**PLANNING & ZONING COMMISSION
REGULAR MEETING
Wednesday, December 6, 2023 – 7:00 PM
Town Hall Meeting Room 1**

RE: Site Plan and Special Permit Application – 131 Linwood Avenue

Project Title:
PROPOSED COMMERCIAL DEVELOPMENT
 131 LINWOOD AVE
 COLCHESTER, CT
 Issued For:
Definitive Site Plan

DATE: November 30, 2023

Drawing No.
C-3

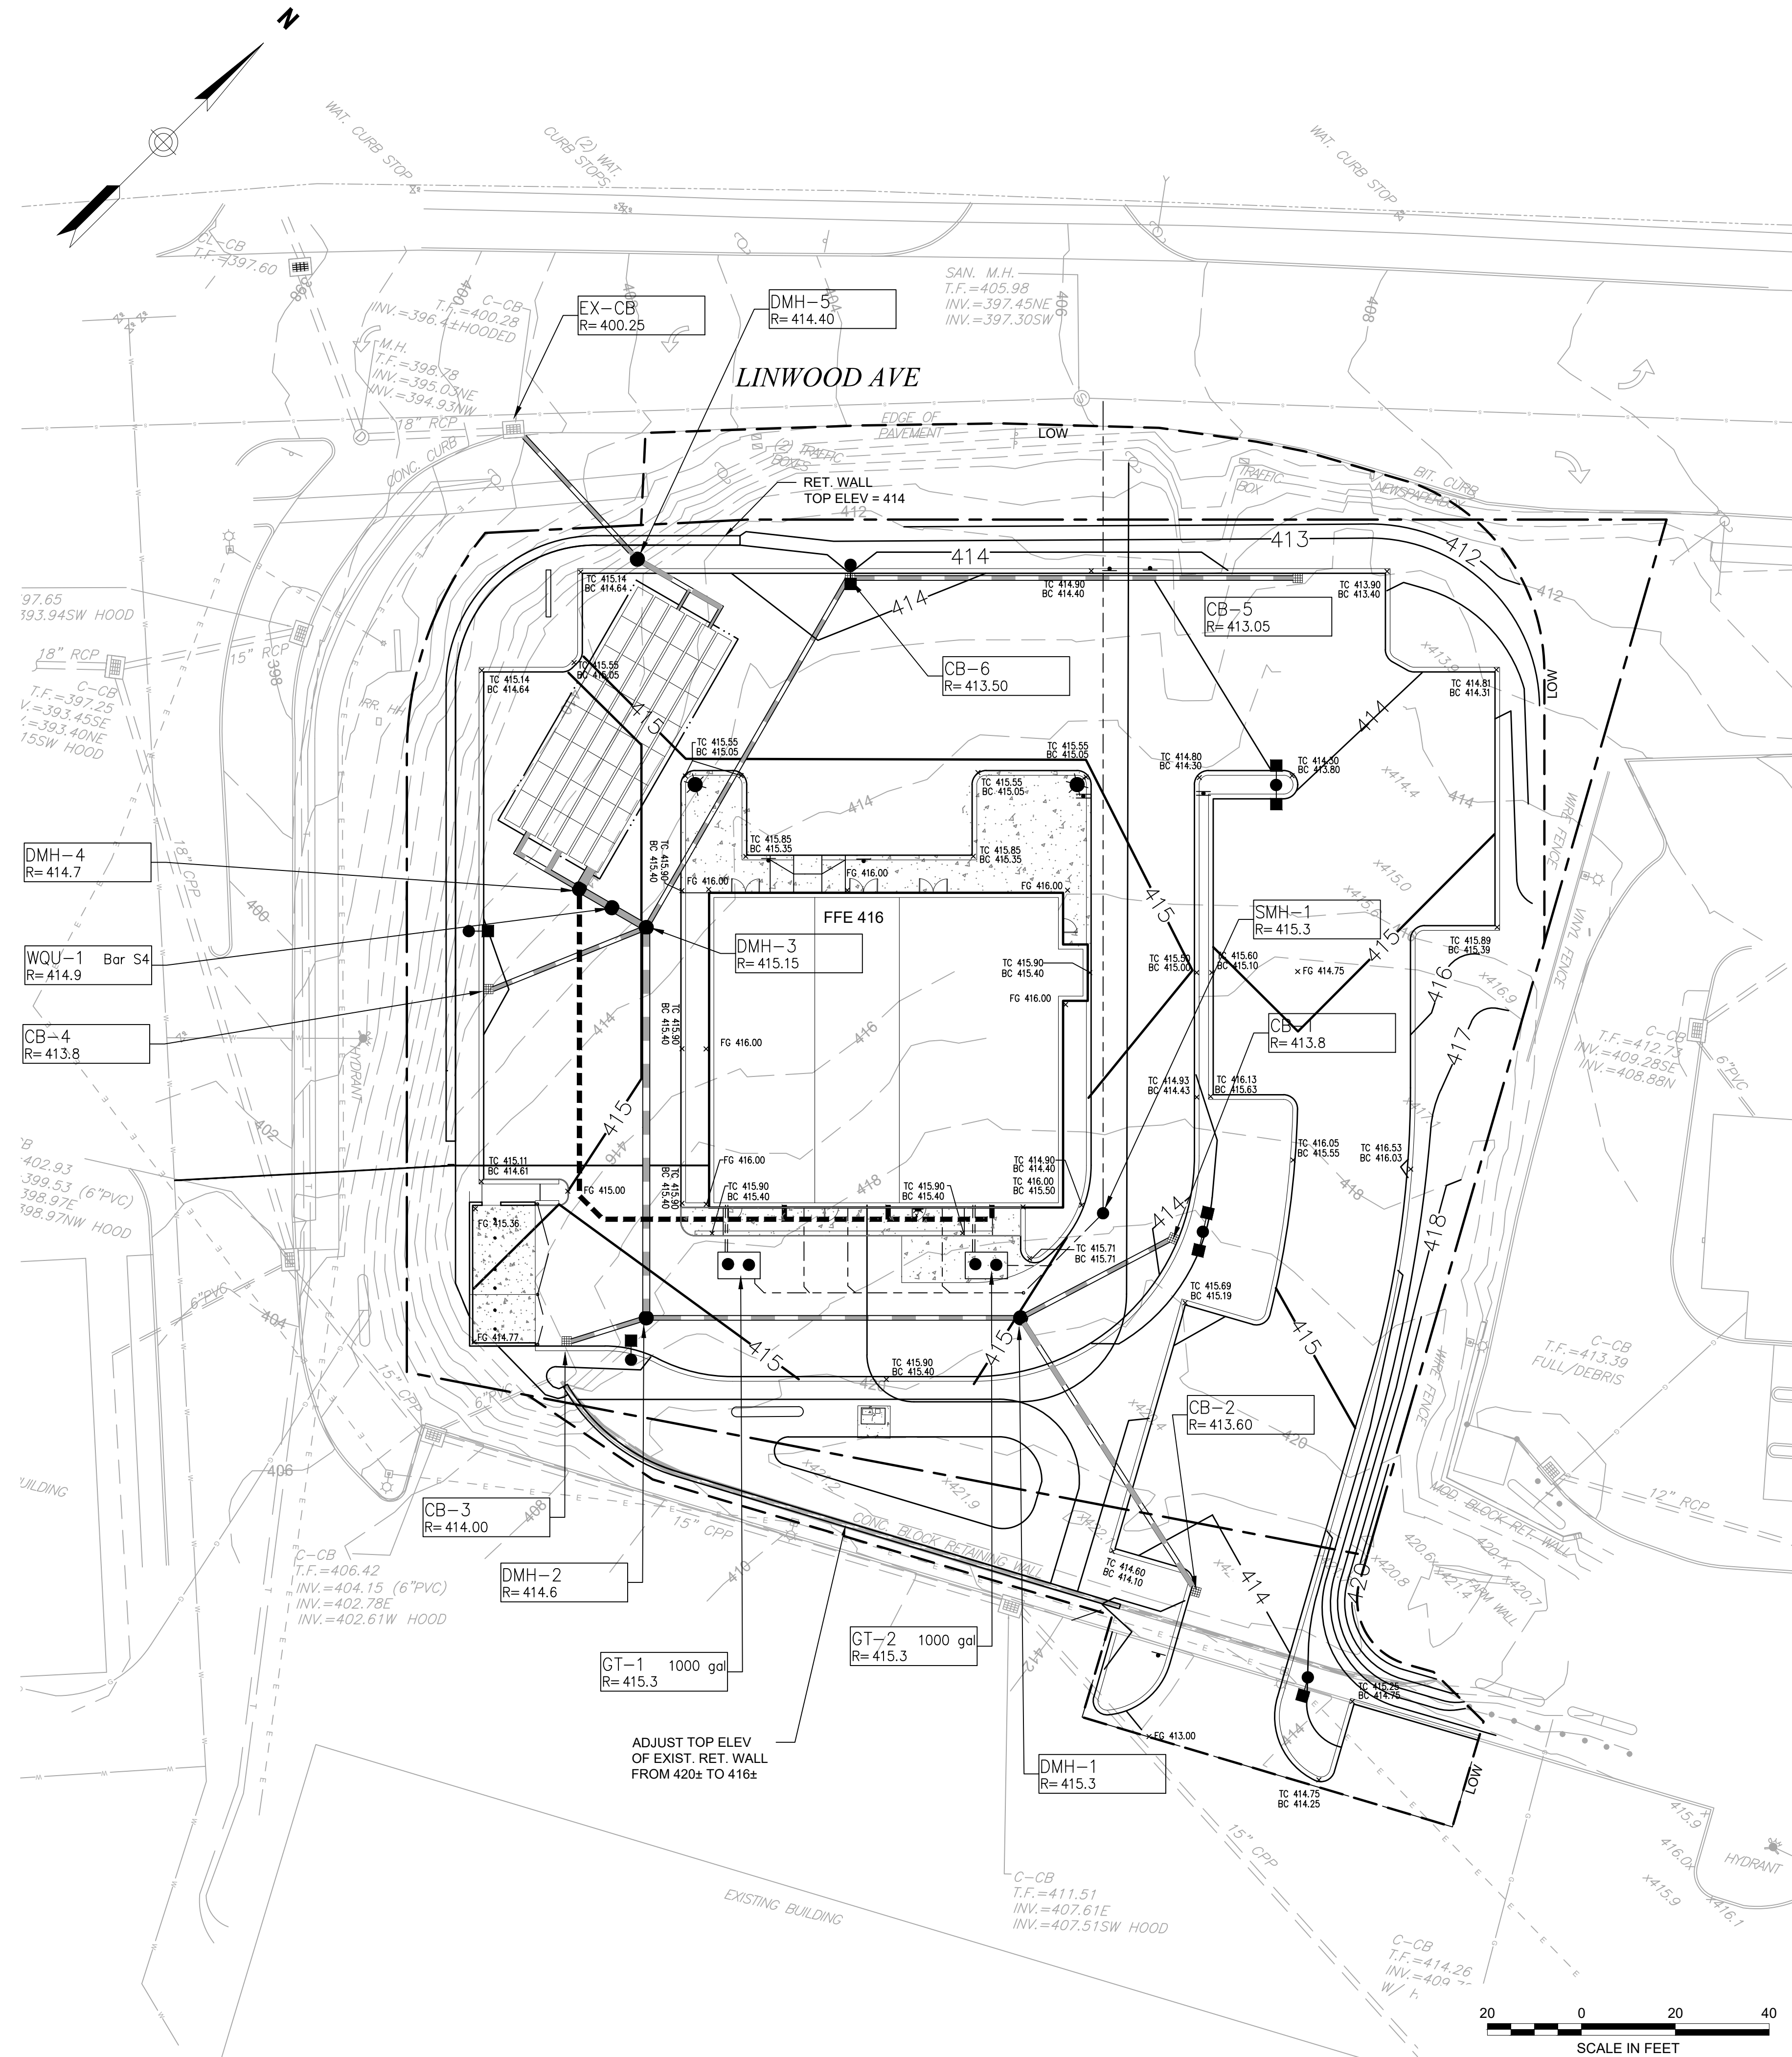
- 10) Should show the maximum number of vehicle stacking spaces within the drive through lane.
- 11) Sheet C-3 and C-4 Note #21 erroneously refers to "The City of Worcester Standards".

- 13) Need to provide construction detail for proposed Water Quality Unit (WQU-1) shown on sheet C-3.
- 14) Need to provide top and bottom of wall elevations for proposed retaining wall shown along North/West sides of site. Also show proposed grading/contours on both sides of wall. Indicate type of wall and provide wall design/construction details.

C-4

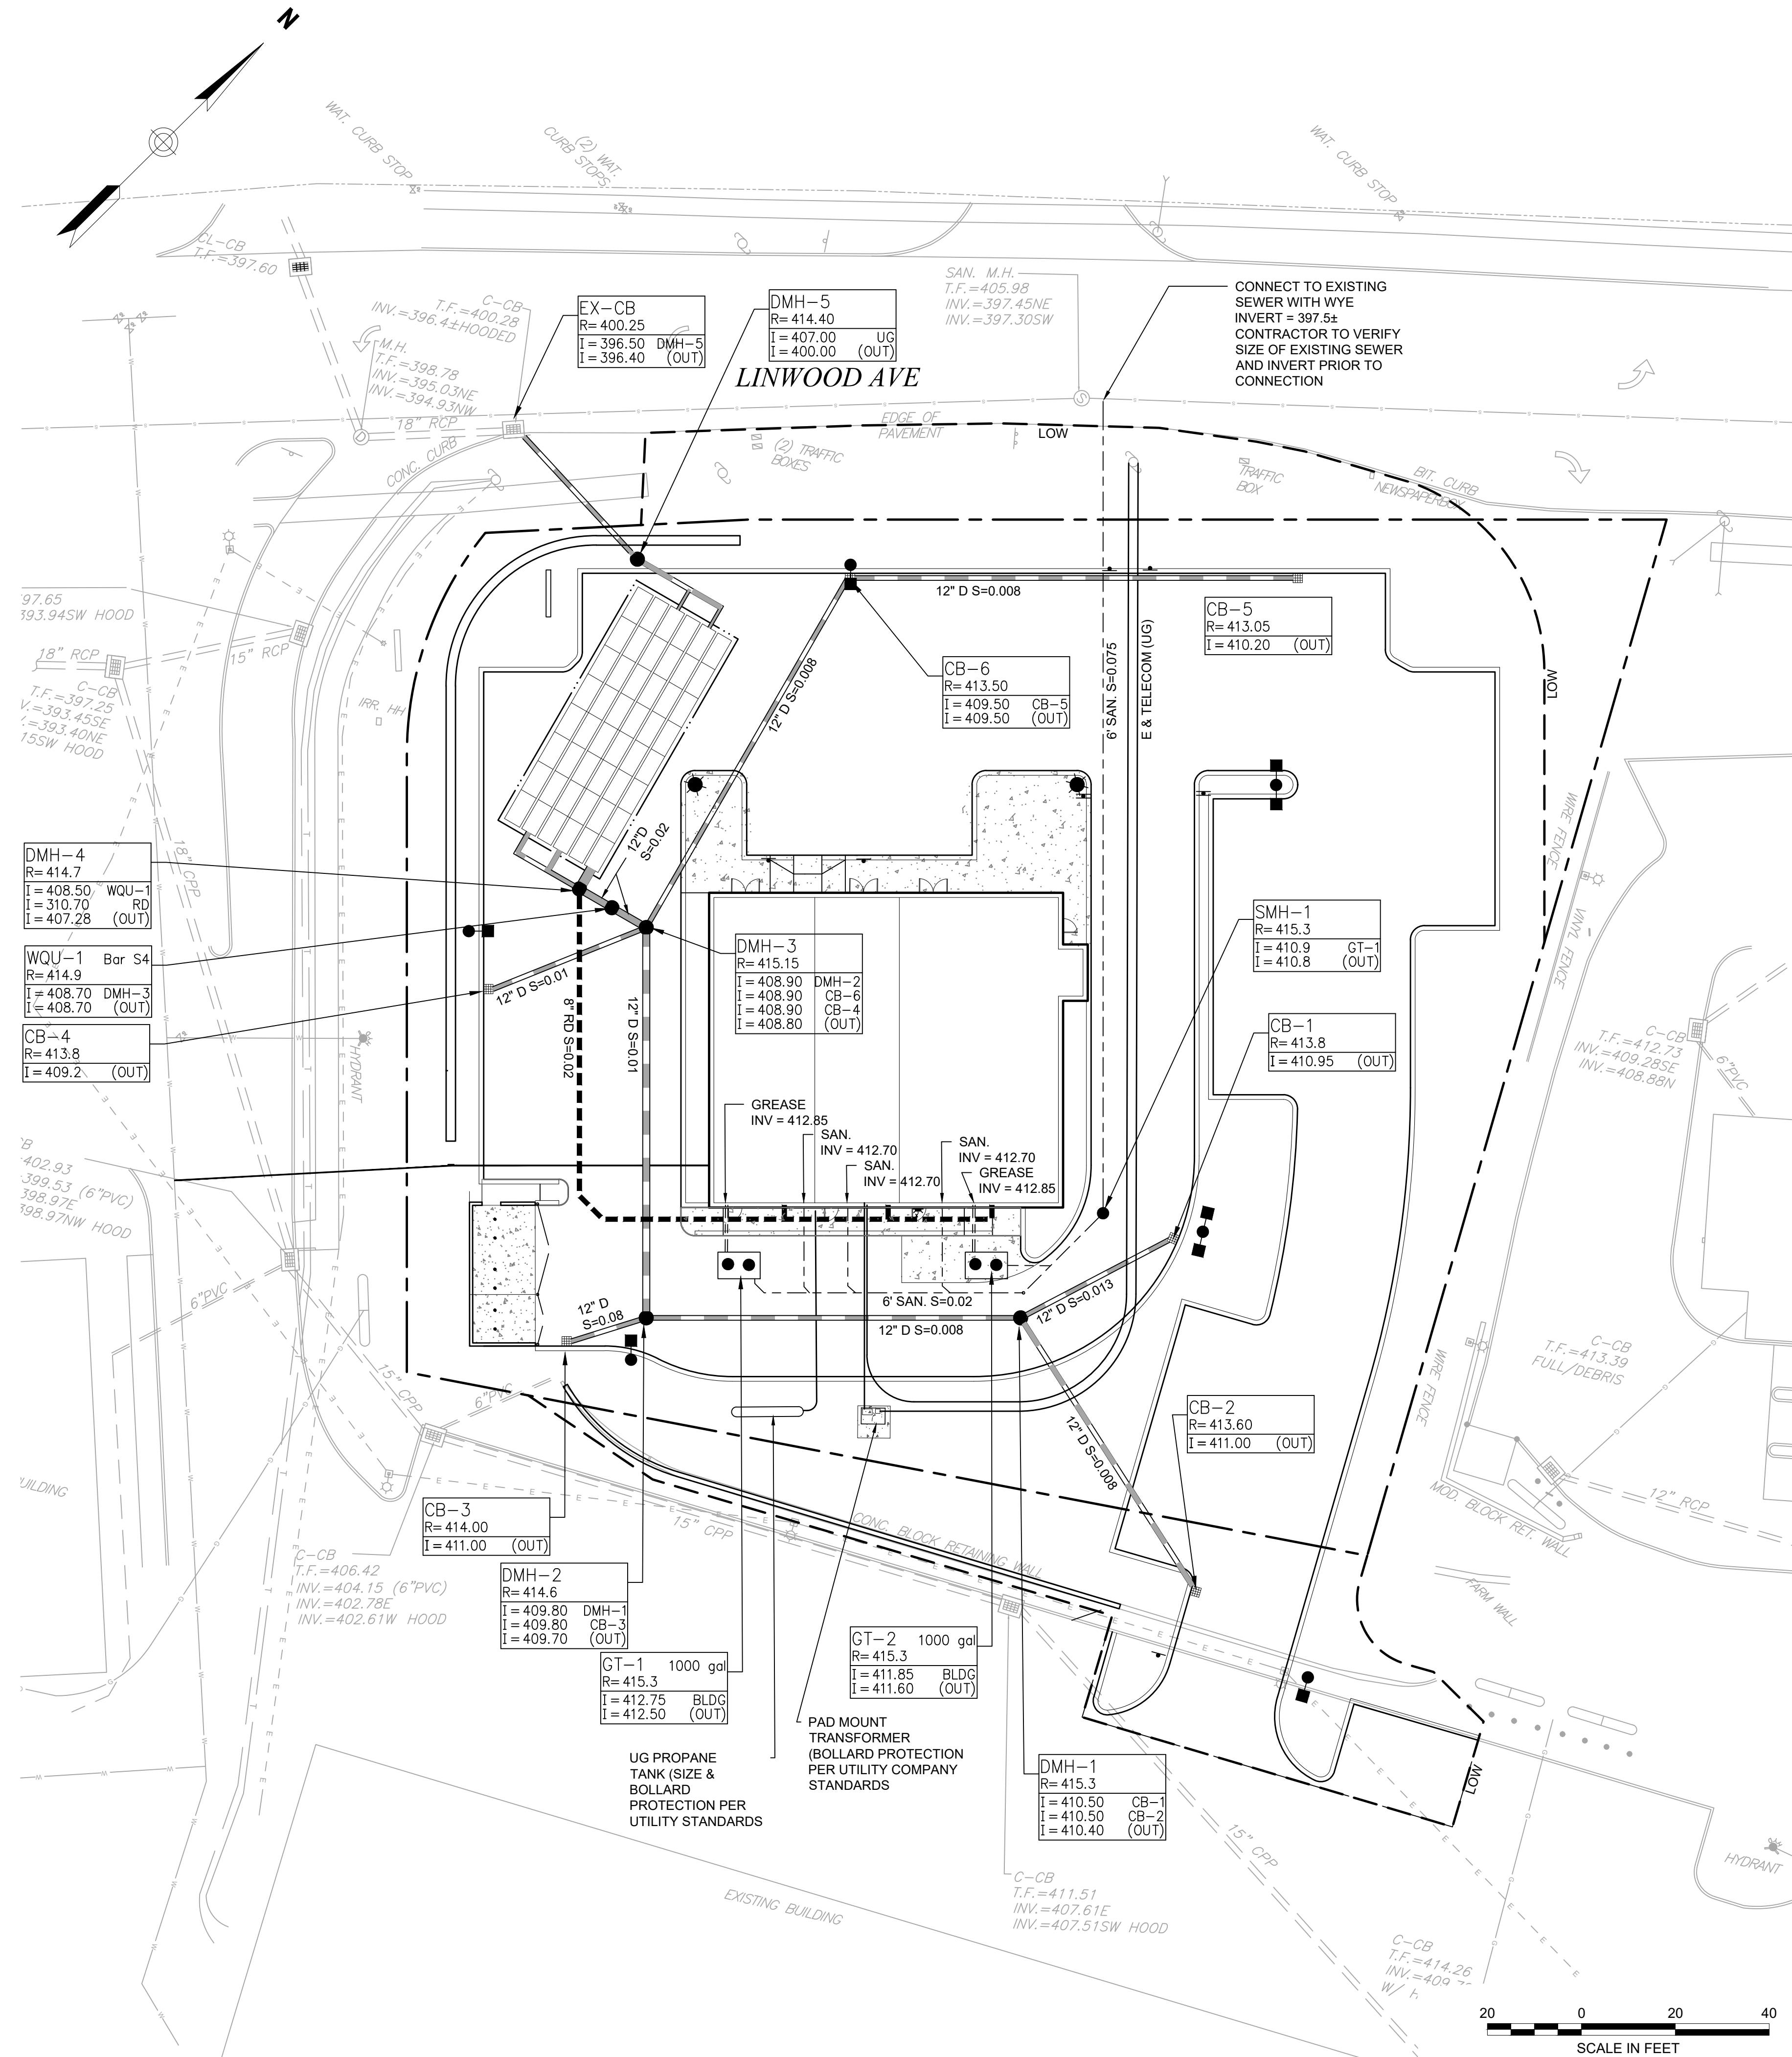
- 15) Show proposed grading/contours west of proposed trash enclosure area.
- 16) Show work required to close off existing Linwood Avenue access drive.
- 17) Need to label all proposed subsurface infiltration system inlet and outlet pipe sizes on sheet C-4.

- 19) The Minimum storm drain pipe diameter per town zoning regulations is 15". Sheet C-4 shows all 12" diameter piping.
- 20) Based on the proposed access drive onto abutting parcel 179 Linwood Avenue, 9 spaces will be eliminated. How will this impact parking space requirements for the existing site development at 179 Linwood Avenue? Will it create a zoning nonconformance for the existing site?

HMA PAVEMENT (ON SITE)
N.T.S.

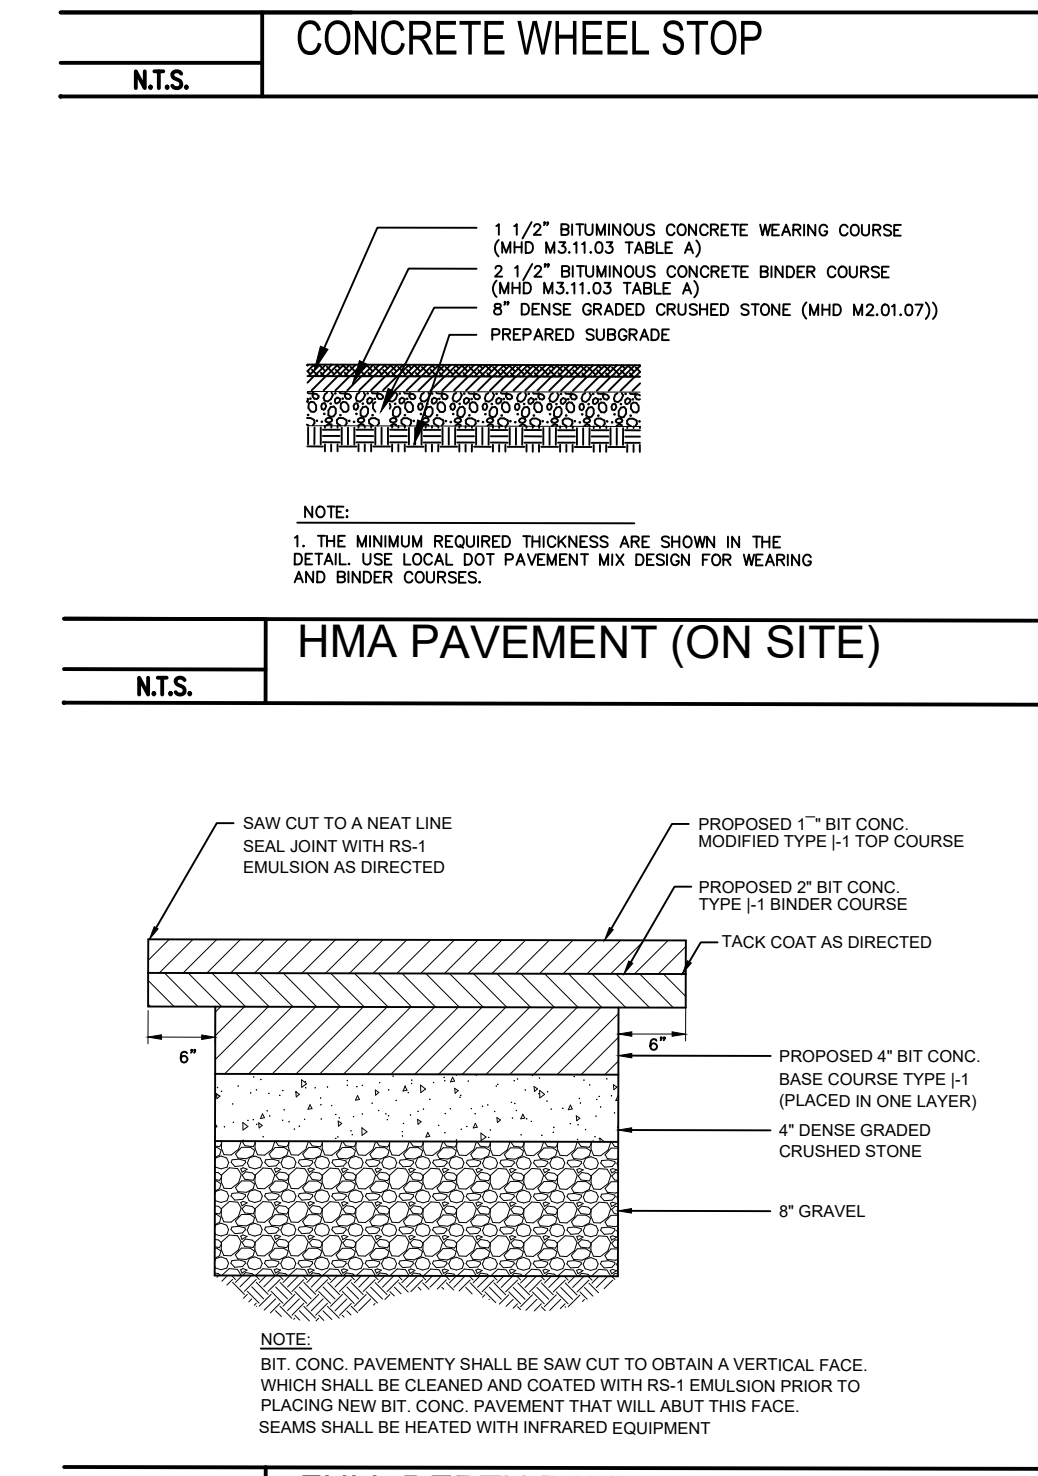
- 21) Need to provide a pervious pavement construction detail.
- 22) Need to provide a concrete sidewalk detail to meet town specifications.
- 23) The HMA Pavement (On-Site) Detail on sheet C-5 does not comply with minimum town specifications relative to required gravel layers. Need minimum 8" processed gravel subgrade meeting DOT M.02.06 gradation B specification and 4" minimum processed aggregate base meeting DOT M.05.01 specifications.

NTS. TYPE C-L CATCH BASIN

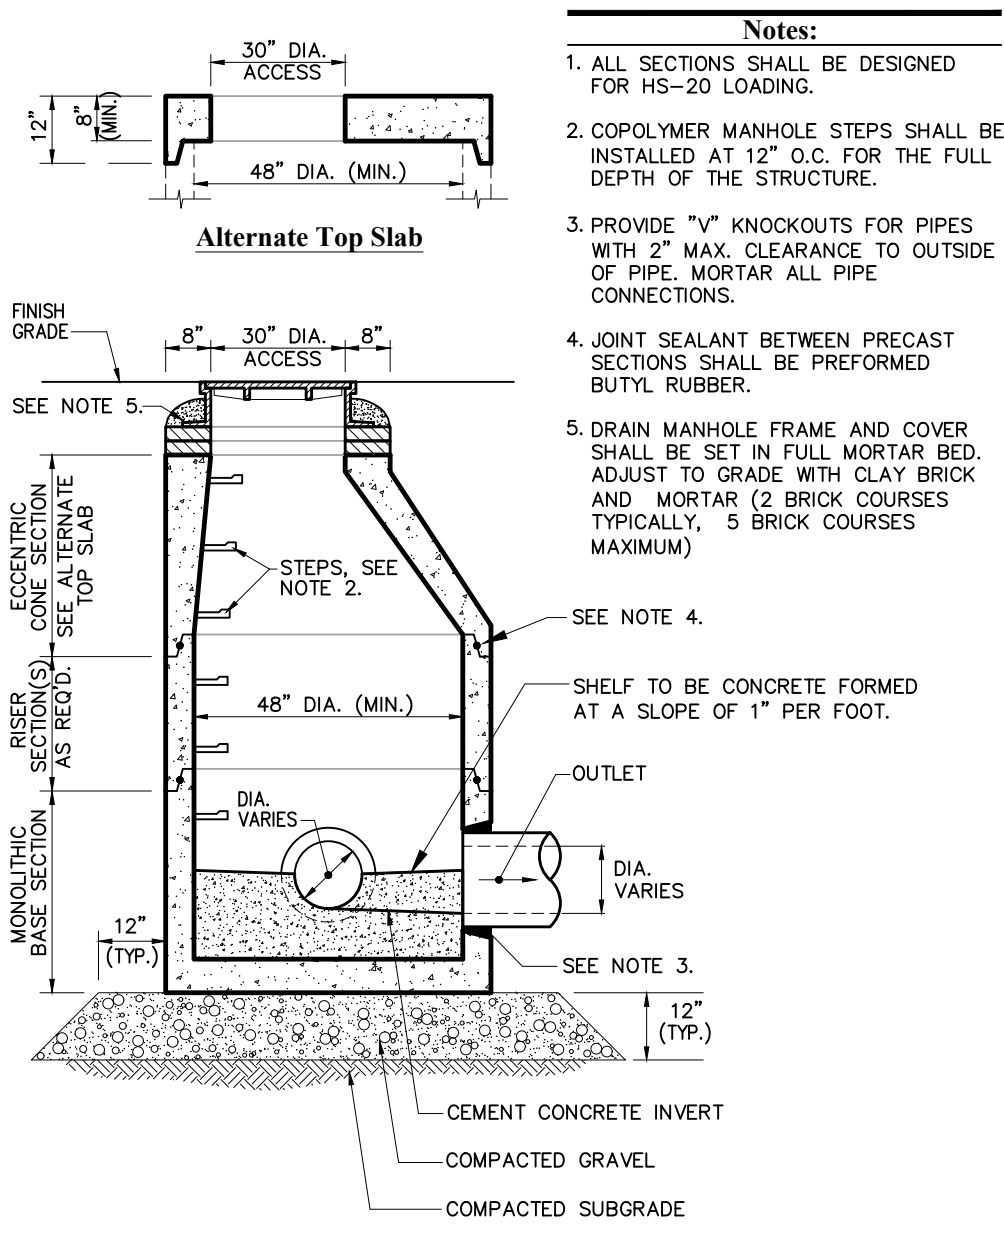
- 24) All proposed catch basins appear to be curb inlet Type C; however, sheet C-6 shows a type C-L CB detail. Need to provide correct detail. Also indicate manufacturer's specification for proposed Hood to be placed over outlet pipes in catch basins.

UNDERGROUND CHAMBER SYSTEM PLAN VIEW

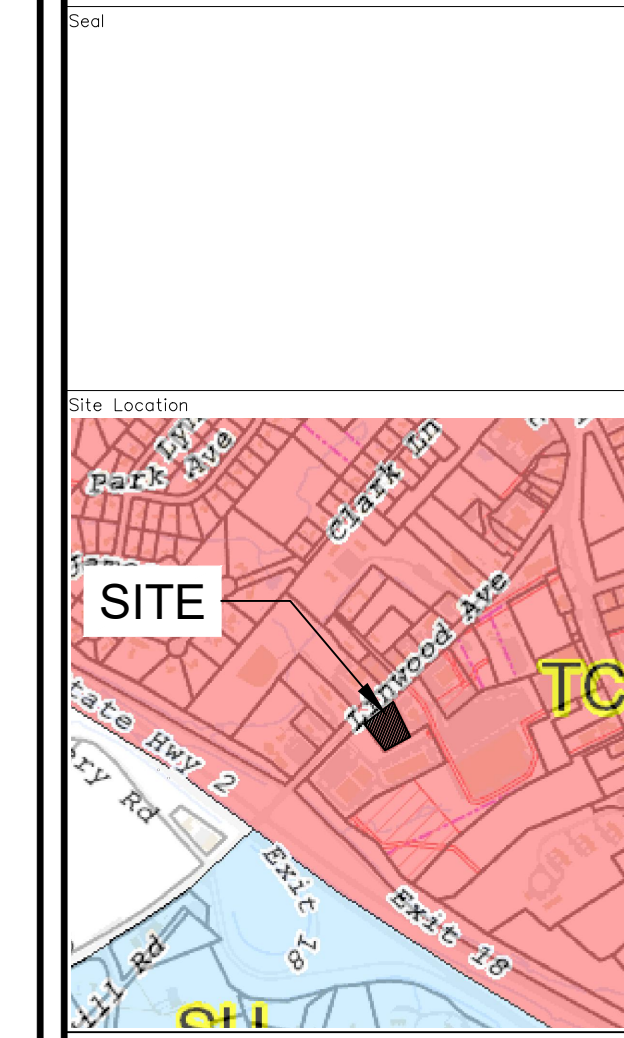
- 25) Based on proposed elevations shown on grading plan sheet C-3, it appears that the "Max F.G. =418.50" shown on sheet C-7 underground chamber system detail is erroneous.
